Staff Report: Preliminary Plan 120050870: Strathmore at Bel Pre, Lot 44
Site Plan 820050330: Strathmore at Bel Pre, Lot 44

MCPB HEARING DATE: December 4, 2008

Proposal for a Preliminary Plan and Site Plan to create one 24,457 square foot (0.561 acres) lot for a private institutional use (modular unit classroom), in the R-90 Zone; located on Layhill Road west of the intersection with Middlevale Lane within the Aspen Hill Master Plan.

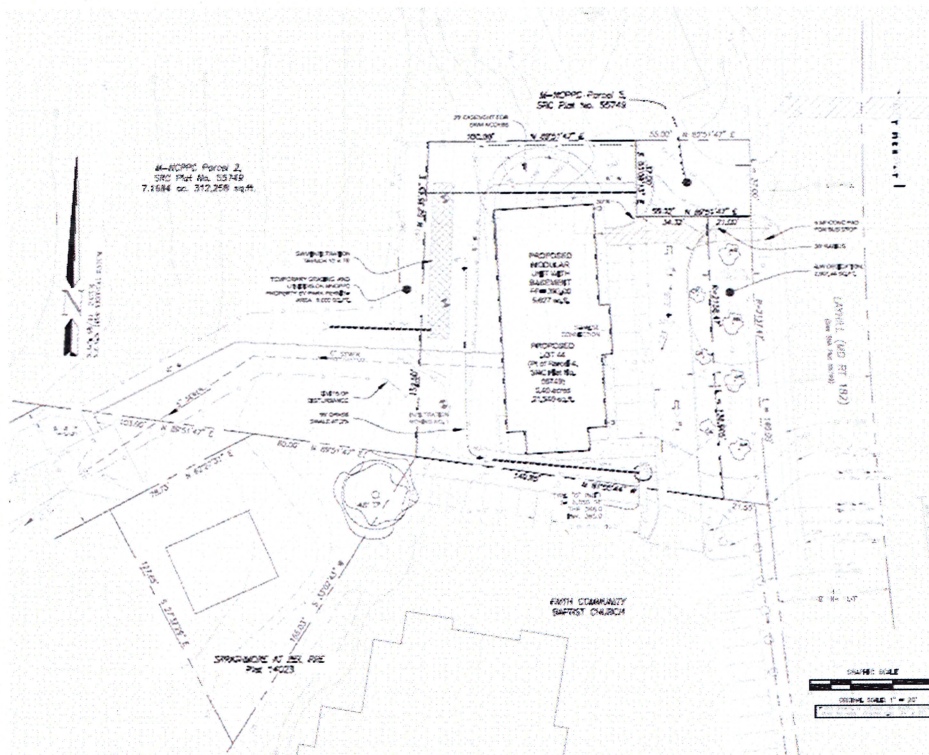
The application proposes to create one lot from the parcel that was previously leased from the SHA by the Faith Arts Academy of Faith Baptist Church and to construct a 10,854 square foot modular unit building with a basement for classroom activities associated with the Church. The Applicant has stated that the expected enrollment is about 30 children. The building is rectangular and is set back approximately 48 feet from Layhill Road. Access to the site is from Layhill Road directly across from the intersection with Middlevale Road and from the adjoining Faith Baptist Church parking lot. Twelve parking spaces are provided in front of the proposed building.

Street trees are provided along the Layhill Road frontage. Additional landscaping will need to be provided to buffer the proposed parking as well as foundation planting for the proposed classroom.

- a. Provide a more common variety of street tree along Layhill Road.
- b. Provide additional foundation planting in the front of the proposed building.
